,		•			
		Application No.	Applicant(s)			
Office Action Summary		10/726,818	FERRELL, JANIS I.			
		Examiner	Art Unit			
		Jon A Szumny	3632			
Period fo	The MAILING DATE of this communication app or Reply	ears on the cover sheet with the c	orrespondence address			
THE - Exte after - If the - If NC - Failt Any	MAILING DATE OF THIS COMMUNICATION. Insions of time may be available under the provisions of 37 CFR 1.13 SIX (6) MONTHS from the mailing date of this communication. In period for reply specified above is less than thirty (30) days, a reply period for reply is specified above, the maximum statutory period we use to reply within the set or extended period for reply will, by statute, reply received by the Office later than three months after the mailing led patent term adjustment. See 37 CFR 1.704(b).	36(a). In no event, however, may a reply be time within the statutory minimum of thirty (30) days will apply and will expire SIX (6) MONTHS from cause the application to become ABANDONE	nely filed s will be considered timely. the mailing date of this communication. D (35 U.S.C. § 133).

This is the third office action for application number 10/726,818, Tableware Clip-On Device, file

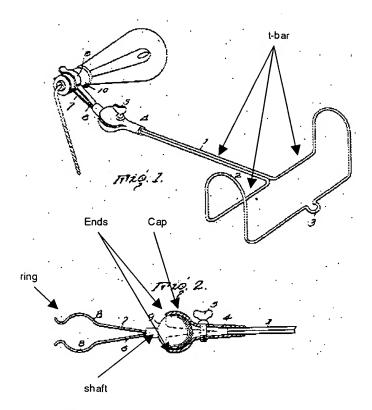
Barnes '894 discloses a clip on device (above) comprising a ring (above) integral with a shaft (above, utilizing same definition of "integral" from above) extending away from a back end of the ring, the shaft connected to a ball (9) at a point distal from the ring, a partially circular cap (above) supporting a t-bar (above) on an exterior surface distal from an opening between a pair of ends (above) on the circular cap, the t-bar supporting a pair of spreadable lips (above, they are inherently "spreadable" since the wire can be "bent", see lines 42-44), wherein the ring is partially a c-ring, and partially a v-ring. However, Barnes '894 fails to specifically teach the ring to be a c-ring. It would have been obvious to one of ordinary skill in the art at the time the invention was made to have constructed the ring of any of numerous shapes, including a c-shaped ring, so long as it still securely fastens to an object, since the particular shape claimed by the applicant is nothing more than one of numerous shapes that an ordinary artisan provides for
